Comments on #CID-25-0003 - Planning & Zoning: Construction Infrastructure Drawing

Application Number: #CID-25-0003
Application Type: Construction Infrastructure Drawing
Date: April 1, 2026
Address: 5109 Mitchell Mill Rd

MITCHELL MILL MARKET
TOWN OF ROLESVILLE, WAKE COUNTY, NORTH CAROLINA
CONSTRUCTION PLANS
COVER SHEET

DRAWING SHEET
C-1.0

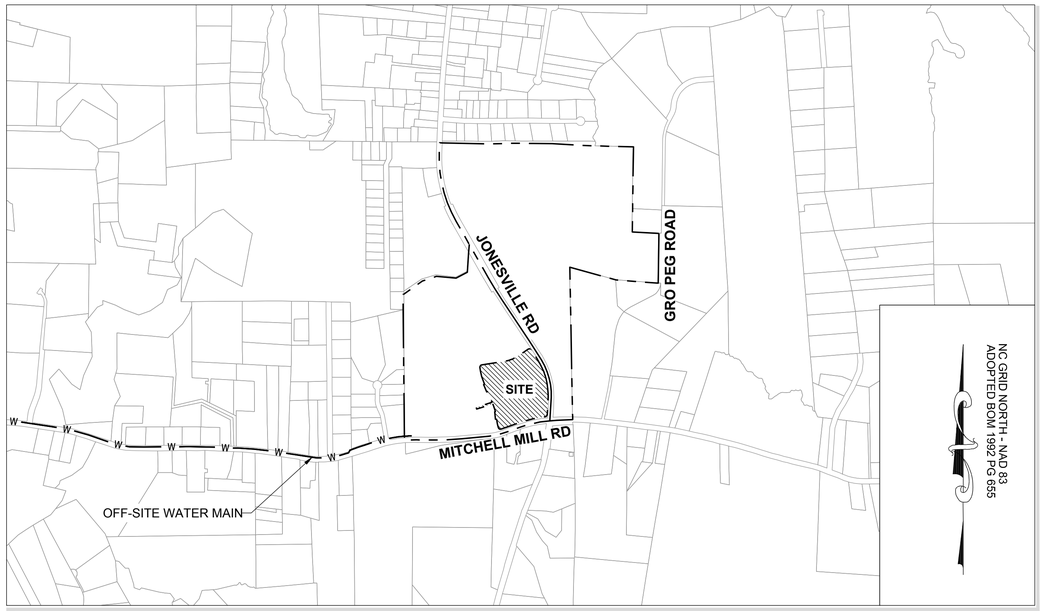
The 'commercial' site area is 8.48 acres, right? Is this meant to express that the zoning entitlement commits to a minimum of 50,000 SF of commercial building space? calling it 'commercial area' is confusing - please revise to something like above that is crystal clear what this note is expressing. TY.

DRAWING SHEET
C-1.0

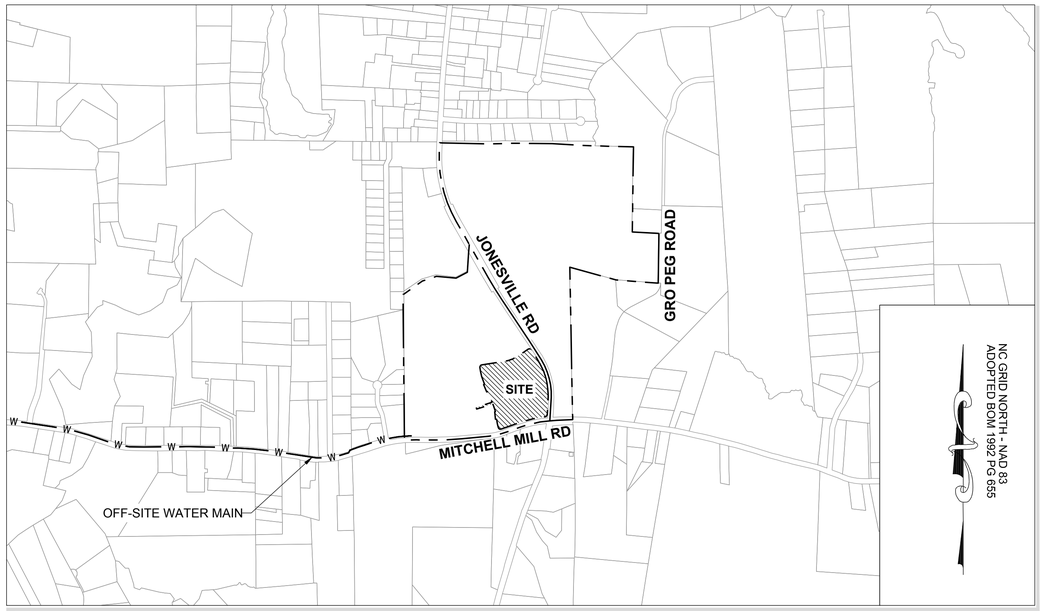
Should this not be per MA 22-06? A PSP is just a preliminary layout of lots, ROW, easements, not developable building square footage. Being a CID for infrastructure, are parking calculations even applicable now on this plan set? This whole table seems more appropriate and applicable on a SDP plan set for ultimate build-out.
